SUTHERLAND SHIRE COUNCIL ASSESSMENT REPORT

Panel Reference	PPSSSH-172
DA Number	DA24/0346
LGA	Sutherland Shire
Proposed Development:	Alterations and additions to existing school, increase student capacity, and the construction of a car parking area.
Street Address:	Lot 1 DP 593896,, Lot 2 DP 1190871, 35A Waratah Road, Engadine, Boys Town Oval 35B Waratah Road, Engadine
Applicant/Owner:	The Trustee For Sydney Catholic Schools Trust
Date of DA lodgement	16 July 2024
Number of Submissions:	17
Recommendation:	Deferred Commencement Approval
Regional Development Criteria	Clause 5, Schedule 6 State Environmental Planning Policy (Planning Systems) 2021 - EDC > \$5M – Private infrastructure and community facilities
List of all relevant s4.15(1)(a) matters	<ul style="list-style-type: none"> • State Environmental Planning Policy (Planning Systems) 2021 • State Environmental Planning Policy (Resilience and Hazards) 2021 • State Environmental Planning Policy (Transport and Infrastructure) 2021 • State Environmental Planning Policy (Biodiversity and Conservation) 2021 • Sutherland Shire Local Environmental Plan 2015 (SSLEP 2015). • Sutherland Shire Development Control Plan 2015 (SSDCP 2015). •

Figure 6: Revised raised driveway, entry / ramp level and flood channel

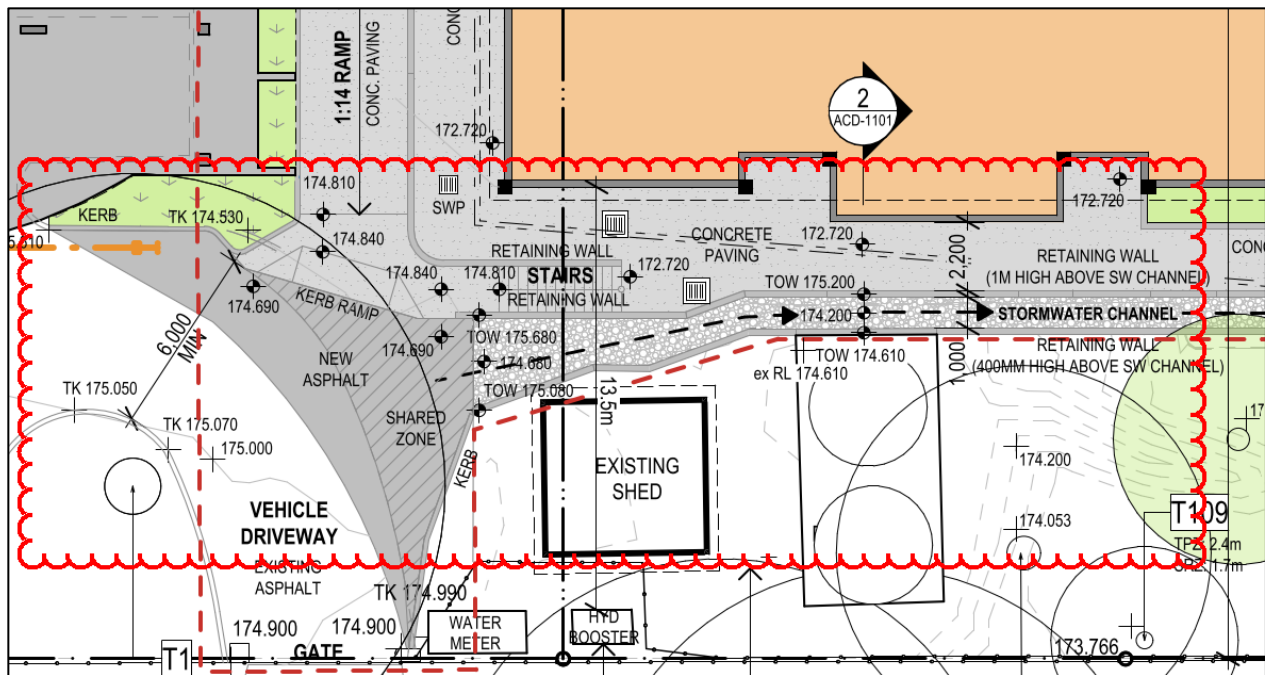
In lieu of a site-specific flood study, the applicant was requested to demonstrate that the proposed development is protected from the ingress of floodwater and to incorporate measures to manage on-site flood behaviour as required, reducing risk to human life and minimising damage to property as per Objective 4.1 in Chapter 40 of SSDCP2015. Given any flood impacts will likely be absorbed within the existing lot, Council requires the building (and internal breezeway) to be protected from upslope runoff and overland floodwaters up to and including the PMF. This requires design amendments to the proposed cut retaining walls, ramp and stairs to the south-east corner and eastern elevation fronting Banksia Avenue.

While the Drains modelling outlined in the Applicant's Flood Statement Letter details the estimated flood conveyance in the PMF event, this is not consistent with Council's Preliminary Flood Study data and Council does not accept the model assumptions and all model inputs. In this regard, the Drains modelling results provided are not considered an accurate representation of flood behaviour at the subject lot and, therefore, do not satisfactorily demonstrate the diversion of floodwater in the PMF.

Given the modelling shortfalls evident, the applicant was requested to simply demonstrate flood protection by means of floodproofing to a minimum 400mm above the invert of any proposed kerb/wall (i.e. max 200mm flood depth plus 200mm freeboard for certainty). This can be feasibly achieved along the full length of the internal kerb and this is anticipated to consist of additional ramping/steps up along the path of travel before descending into the development. Supplementary walls and/or other floodproof elements are required to contain the PMF flood to the corresponding level with freeboard, measured at the upslope edge to be RL 174.84m AHD.

The amended architectural design indicates a 150mm height difference between the top of stairs and new driveway level (RL 174.84 vs IL 174.69m AHD) which is depicted in the figure below and hence does not meet the above minimum criteria.

This is a consequence of raising the existing driveway surface in conjunction with the adjoining raised entry ramp / stair. This raised entry / ramp level is provided at an acceptable finished level should the existing driveway surfacing be retained. This would likely require the replacement of the kerb ramp with stairs comprising 2 to 3 risers. Whilst the applicant has failed to demonstrate that the proposed measures will contain flow to the eastern setback and divert floodwaters to the north, conditions of development consent are provided including required design amendments to meet the intent above.

Figure 7, 8 & 9: Plans of complete / incomplete works under DA13/1167.

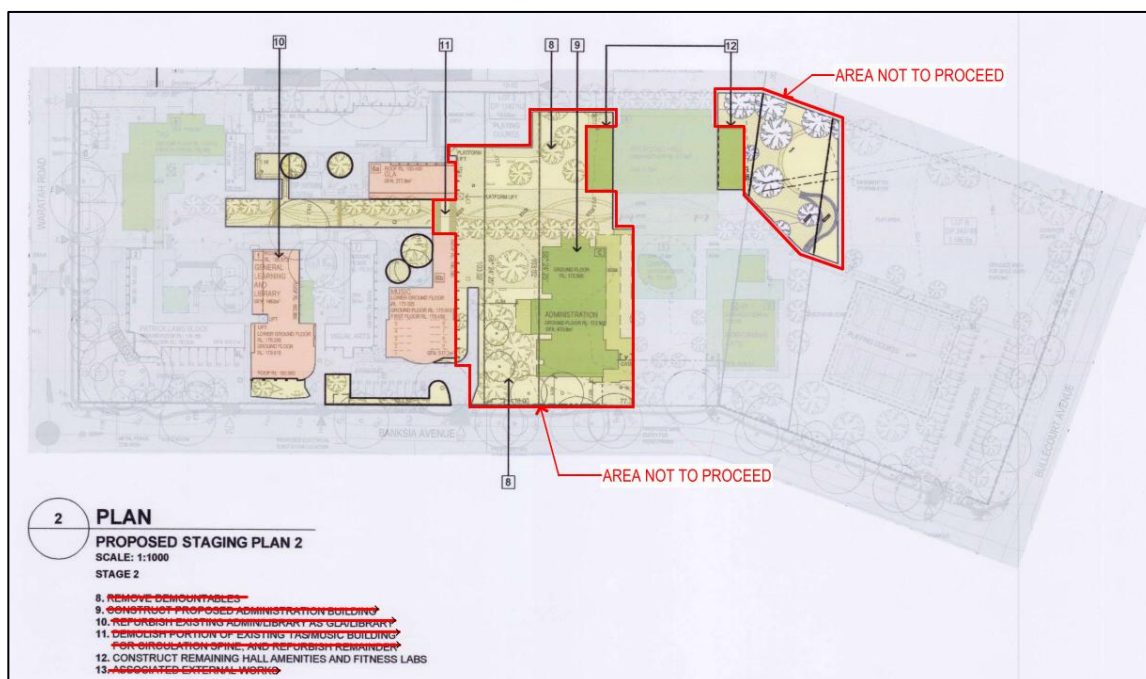
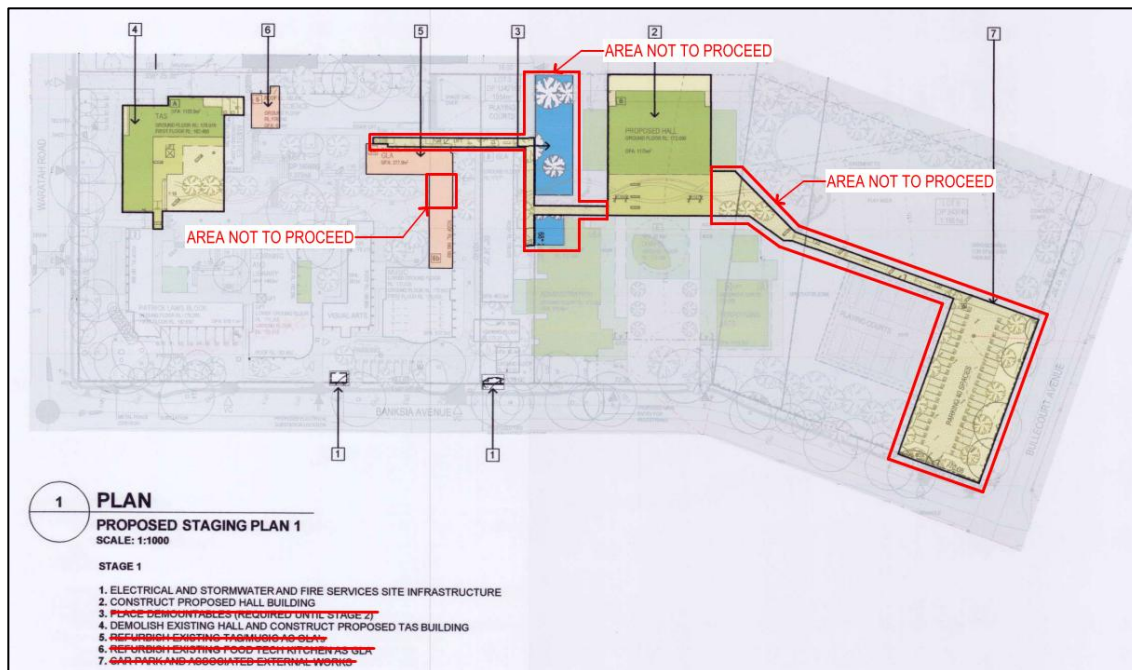
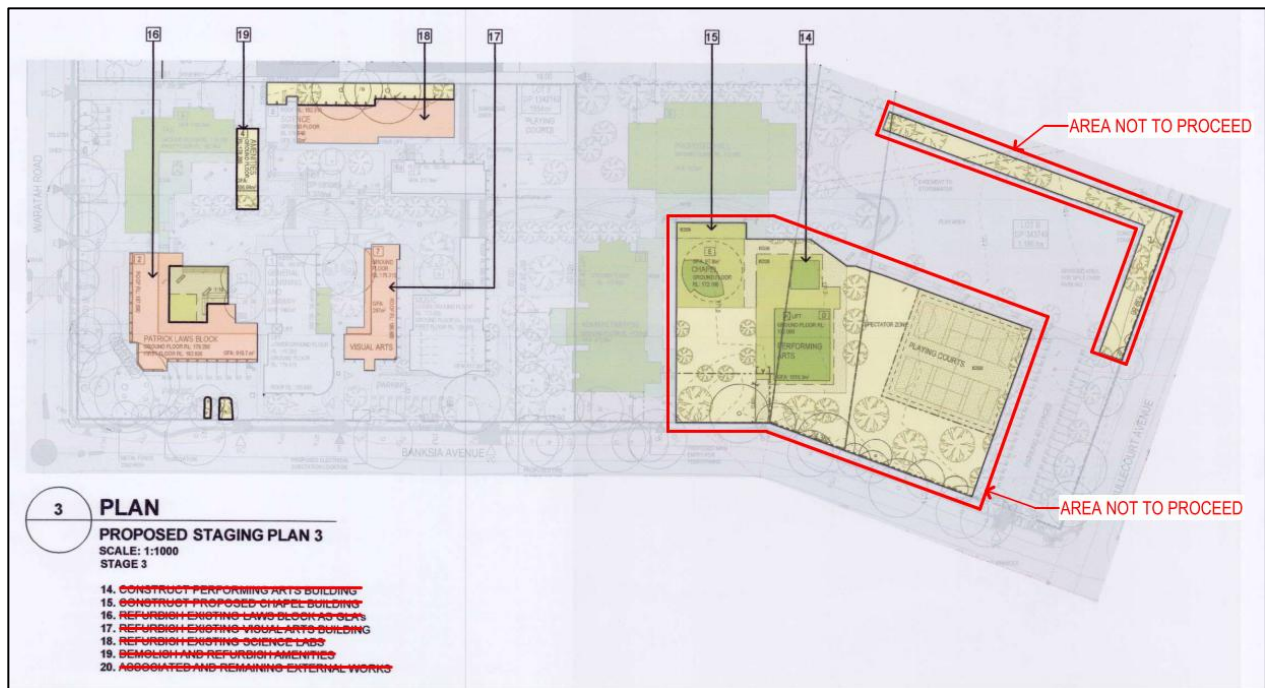
The proposed building is sited in a location which conflicts with elements of the above approved development. The applicant has provided clarification and a plan as to the works which have been undertaken and completed under DA13/1167 along with the scope of works proposed not to proceed and requested to be extinguished under this current development application. The works identified in **Bold** above reflect the completed works and a diagram of the staged works is provided in the figures below. The diagrams indicate the area of works that are not intended to be carried out as well as the works that have been completed.

To address this conflict, the consent authority is able to impose a condition of consent on the subject application which requires the existing consent to be modified. The mechanism in doing so being provided under Section 4.17 (b) of the Environmental Planning and Assessment Act 1979 (Imposition of Conditions) which states:

To ensure the orderly development of the land and to remove the conflict between the subject application and existing development consent, Council is of the view that this is most appropriately resolved via a deferred commencement condition which requires DA13/1167 to be amended and the detailed plan extinguishing the relevant works endorsed.
